INDEX MAP  
 TRACT No. 23809  
 P.C. 7413  
 Scale: 1" = 600'  
 Note: Numbers in circles indicate  
 Page Numbers

PROFILE ALIGNMENT AND GRADE OF  
 SANITARY SEWERS PAGE 1  
 TO BE CONSTRUCTED IN

TRACT No. 23809  
 PRIVATE CONTRACT NO. 7413

PC 7413 PAGE 5  
 DOUBLE SCALE  
 CHANGES / LAS VERGUES  
 MUNICIPAL WATER DIST.

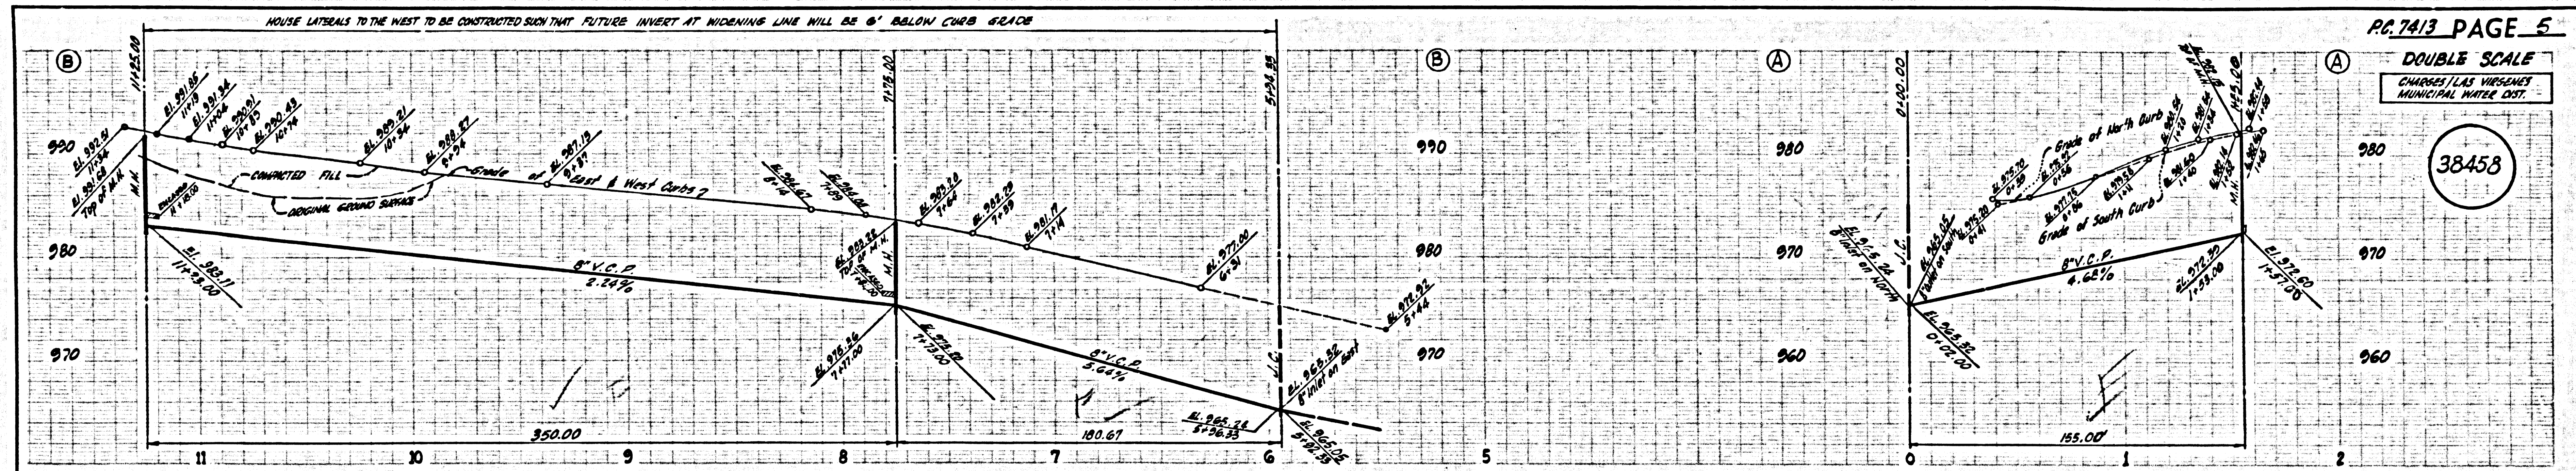
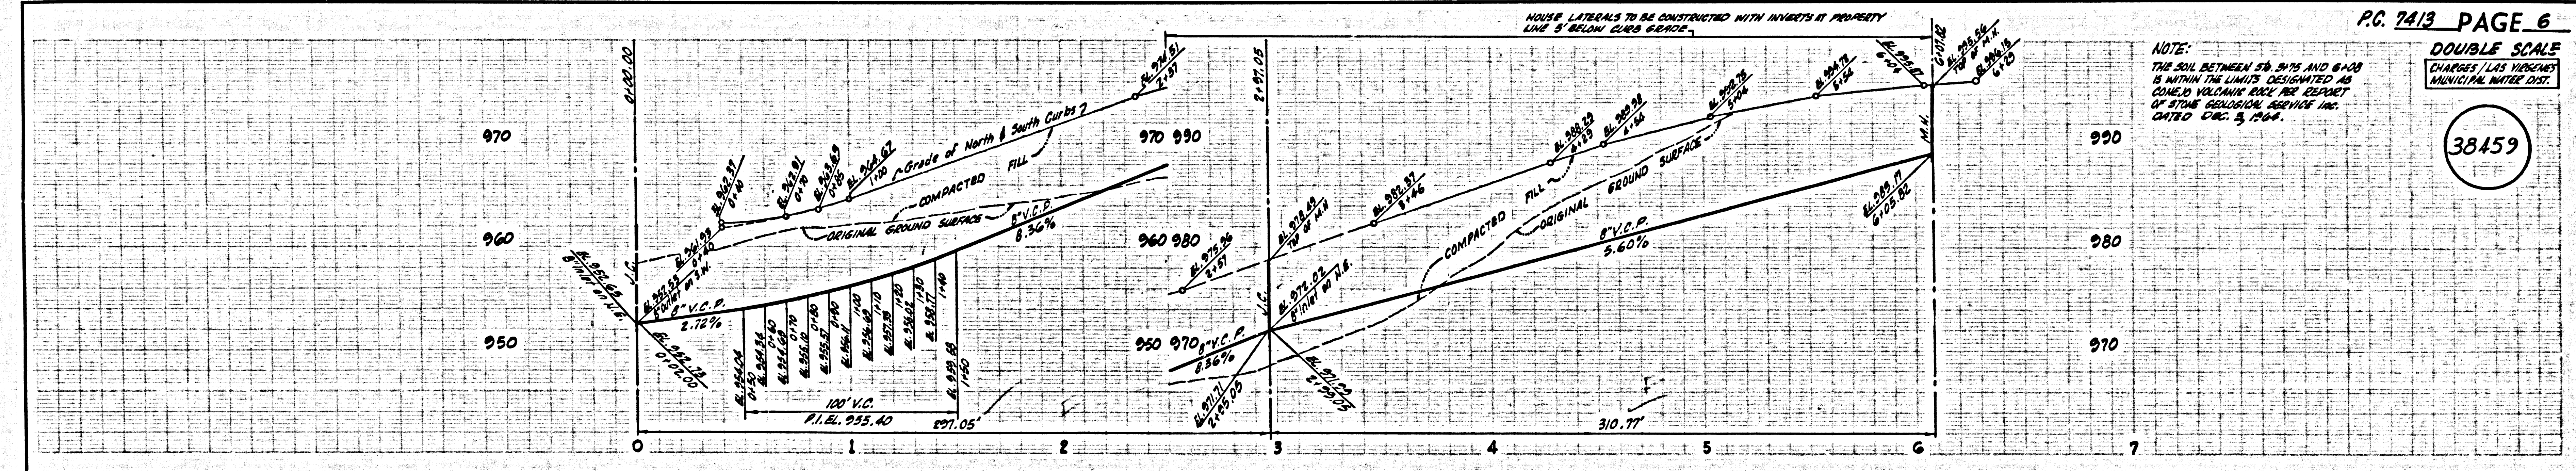
REVISION: 8-30-71  
 PAGE 5-B - REVISED LEGAL ON  
 INSIDE OF MAINWALL DR. N. OF  
 SLUGS CIRCLE FROM TR. NO. 23809  
 TO PAR. MAP NO. 2278.  
 APPROVED: *[Signature]*  
 OFFICE OF COUNTY ENGINEER

REVISION: 2-23-66  
 PAGE 4 - ADD CHIMNEY BASE AND RELOCATE Y'S  
 AND H.L.'S TO N.W. CORNER 215' X 125'  
 PAGE 5-B - EXTEND MAIN LINE 35' ABOVE M.H. &  
 18" DIA. TO HYDROL. RELOCATE H.L.'S TO WEST  
 APPROVED: *[Signature]*  
 OFFICE OF COUNTY ENGINEER

REVISION 12-8-65  
 Page 4 Add I.M.L. & 1" rise and  
 relocate M.L. & Y's to north  
 Page 5 Move upper M.H. from 11425.00  
 to 10725.00. Relocate M.L.'s to West  
 APPROVED: *[Signature]*  
 Office of County Engineer

PC 7413 PAGE 5  
DOUBLE SCALE  
CHANGES LAS VIRGENES MUNICIPAL WATER DIST.

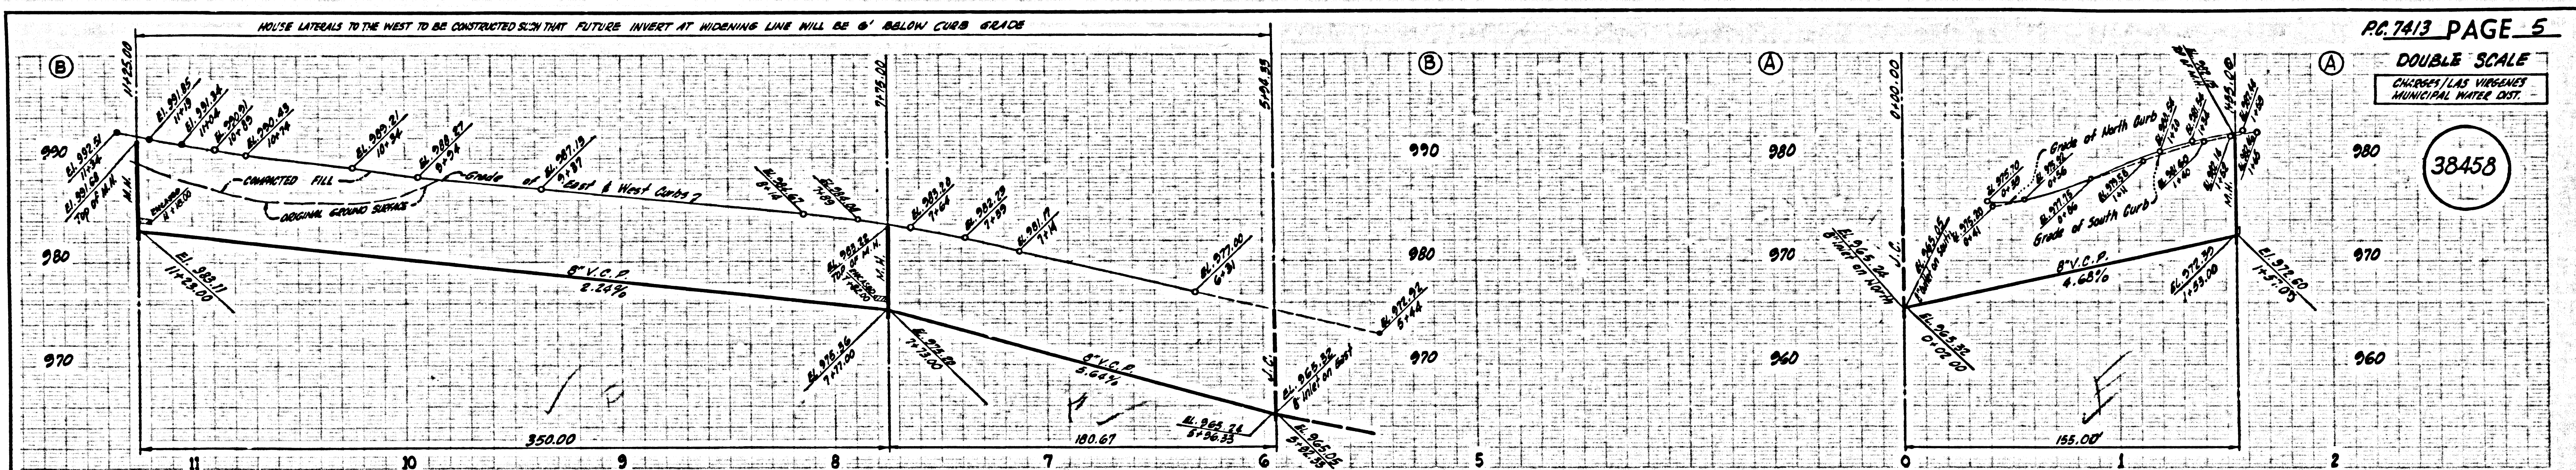
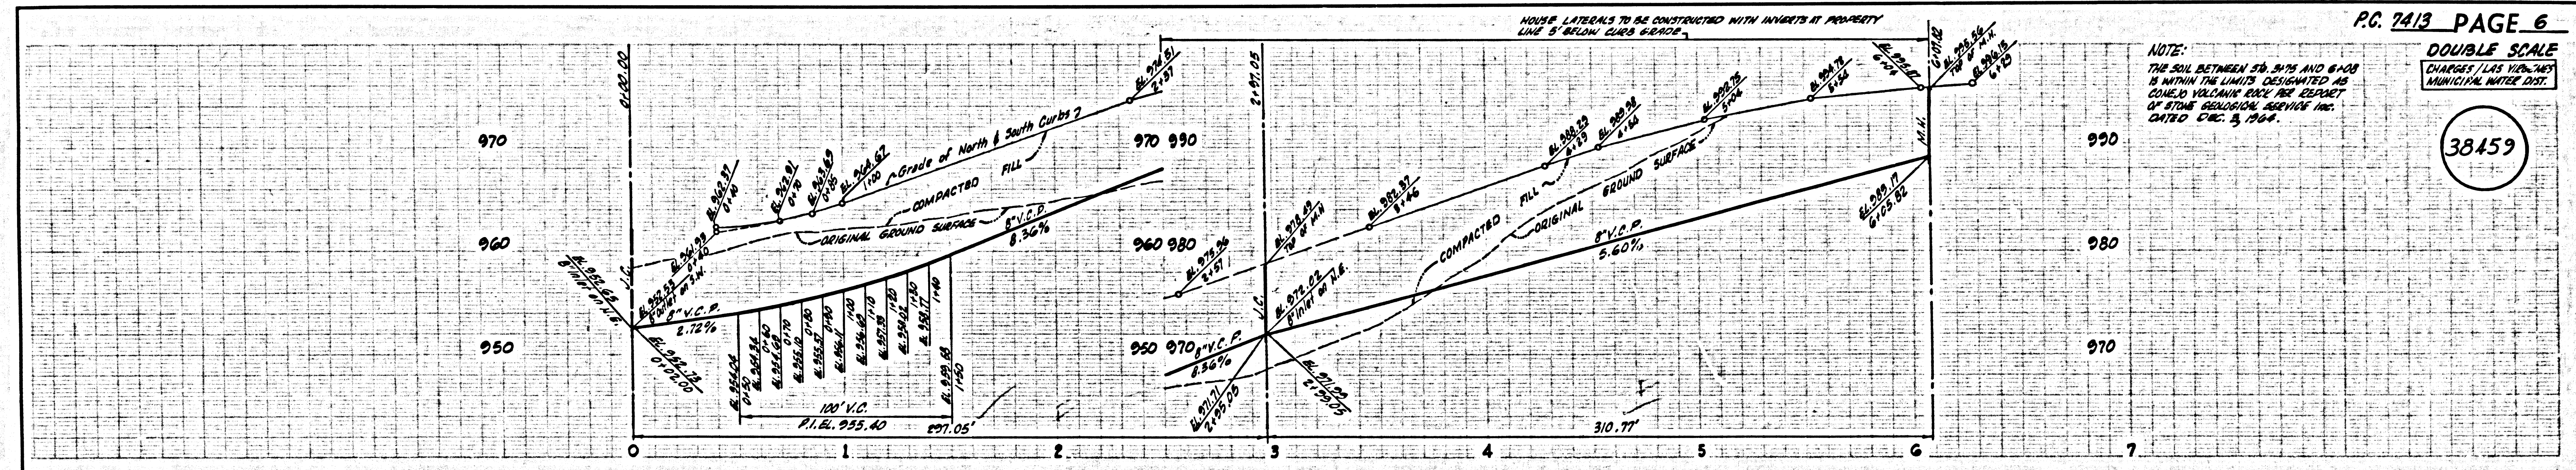
REVISION: 8-30-71  
 PAGE 5-B REVISED LEGAL ON  
 W. SIDE OF MAINMAST DR. N. OF  
 SLICERS CIRCLE FROM TR. NO. 23809  
 TO PAR. MAP NO. 2270.  
 APPROVED: *[Signature]*  
 OFFICE OF COUNTY ENGINEER

REVISION: 2-23-66  
 PAGE 4 - ADD CHANNEY BASE AND RELOCATE Y'S  
 AND H.L.'S TO MK. DELATE 2 Y'S & 2 H.L.'S  
 PAGE 5-B - EXTEND MAIN LINE 35' N.W. BY M.H. 8  
 BY 51.20 TO 1125.00. RELOCATE H.L.'S TO WEST  
 APPROVED: *[Signature]*  
 OFFICE OF COUNTY ENGINEER

REVISION: 12-9-65  
 Page 4 Add 1 H.L. & 1 wye and  
 relocate H.L. 6 1/2' to north  
 Page 5 Move upper M.H. from 1125.00  
 to 1095.00 Relocate H.L.'s to West  
 Approved: *[Signature]*  
 Office of County Engineer
